# C2M module $R_{\text{peak}}$

D3.1 comment #240

Alexander Rysin and Piers Dawe, NVIDIA

# Simulation: COM vs $R_{\text{peak}}$ , D3.1 reference model

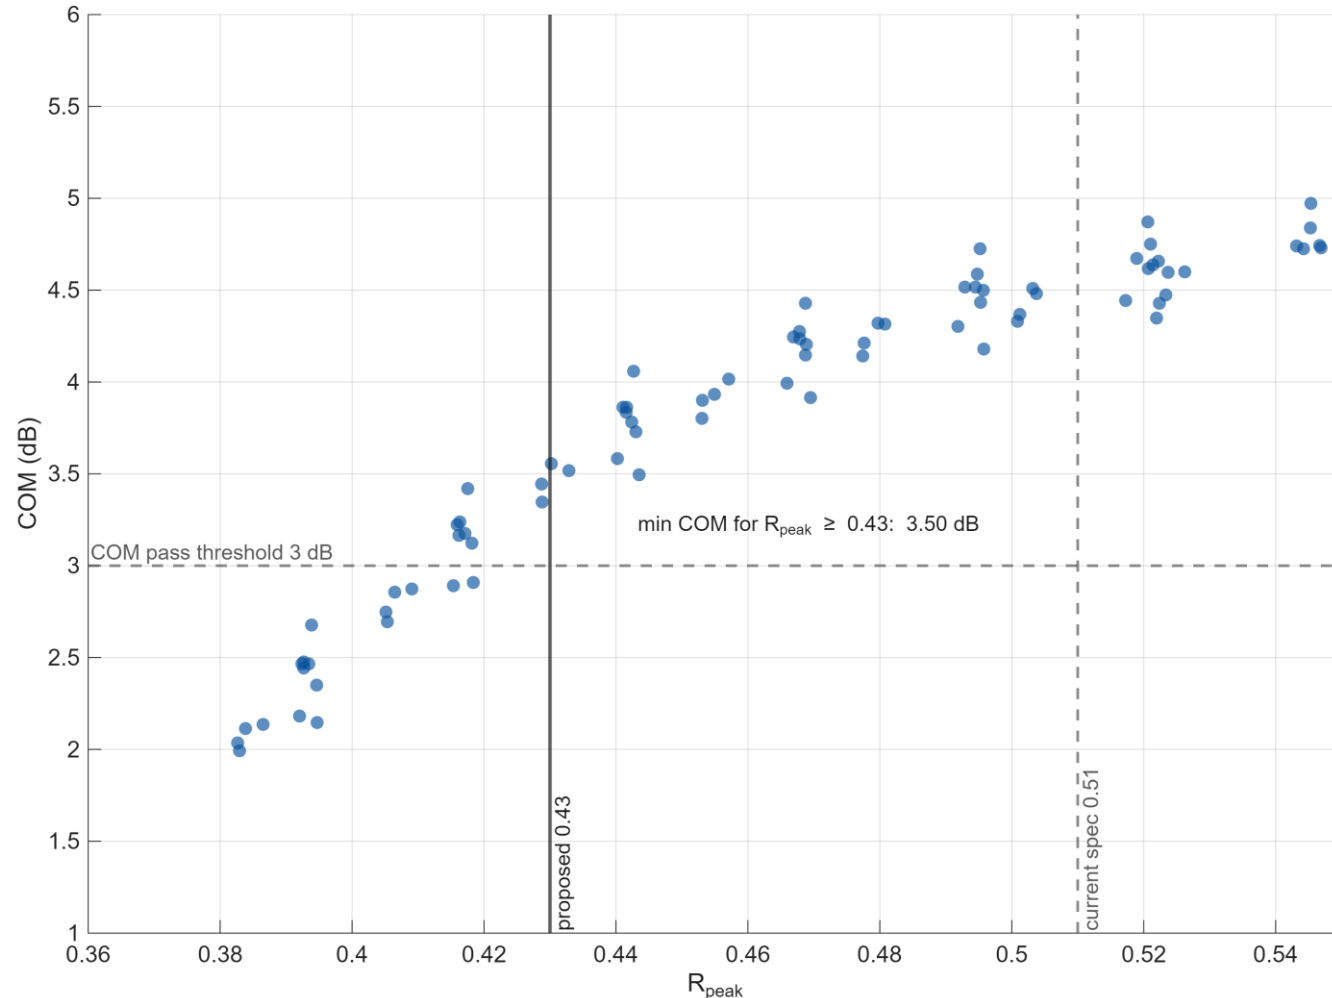
- Numerous mated pair channels
- $R_{\text{peak}}$  was altered by TX transition time sweep
- At the reference  $T_r = 4$  ps,  $R_{\text{peak}} = 0.52$  to  $0.55$ 
  - Marginal to the current limit
- Min COM at  $R_{\text{peak}}$  of  $0.51$  is  $4.35$  dB
- Min COM at  $R_{\text{peak}}$  of  $0.43$  is  $3.5$  dB
  - well above the  $3.0$  dB requirement

# Same conclusion with a module package (informative)

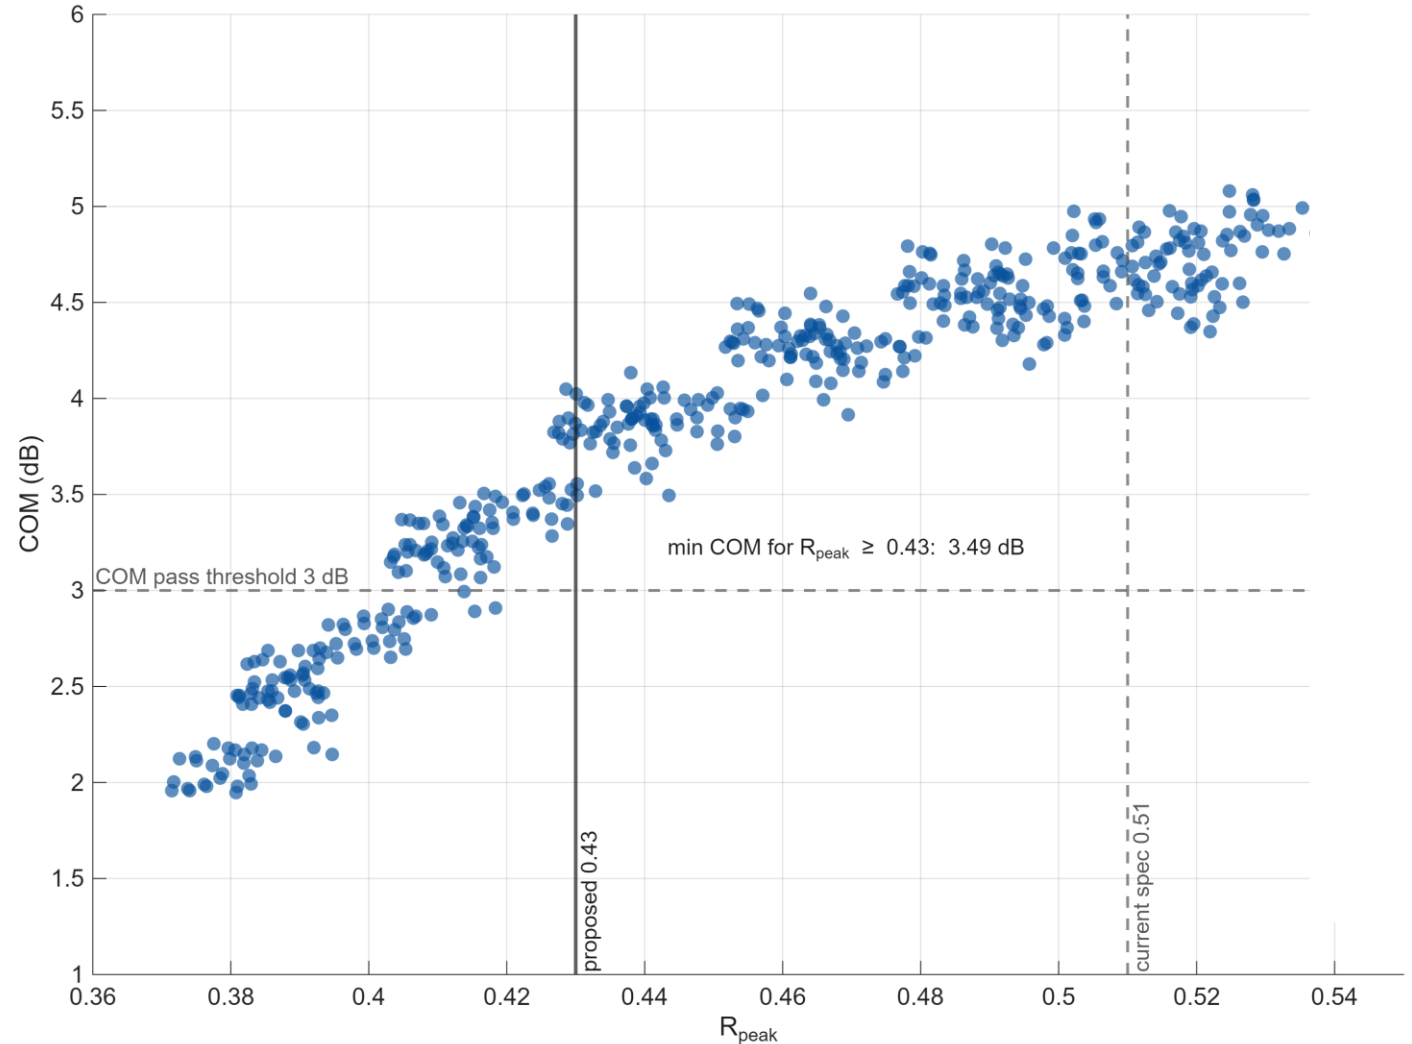
- Same sweep, adding the module device package from the pre-D3.1 draft:
  - informative only: D3.1 removed the module package from the reference model
- COM-vs- $R_{\text{peak}}$  relationship is unchanged.

# Minimum COM vs. $R_{\text{peak}}$ limit

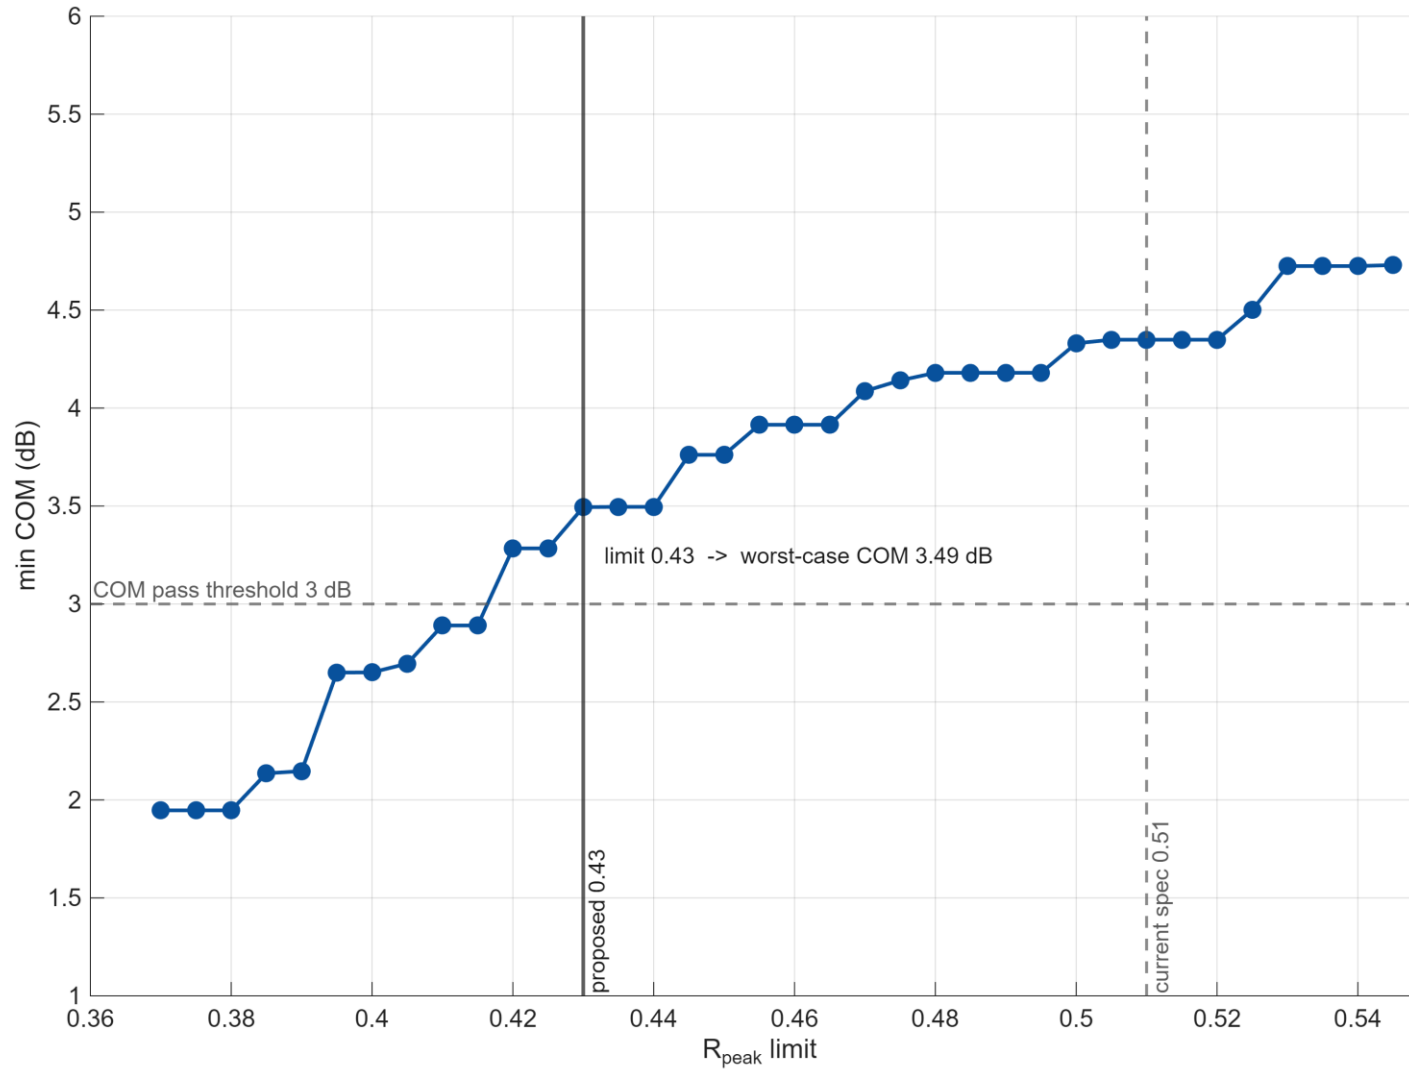
\* min COM = worst COM among all simulated points with  $R_{\text{peak}} \geq \text{limit}$

- The current  $R_{\text{peak}}$  limit cannot be met even for slight deviation from the COM reference model.
- Data from recent interoperability events (e.g. calvin\_3dj\_01a\_2601) show that most tested modules cannot meet the  $R_{\text{peak}}$  and  $v_f$  specifications together for the same TX preset. With that, these modules exhibited good interoperability with compliant hosts.
- $R_{\text{peak}}$  limit of 0.43 will ensure compliance of modules that proved proper interoperability without compromising the link quality.
- Suggested remedy – change the module output  $R_{\text{peak}}$  limit (Table 176D-3) to 0.43.
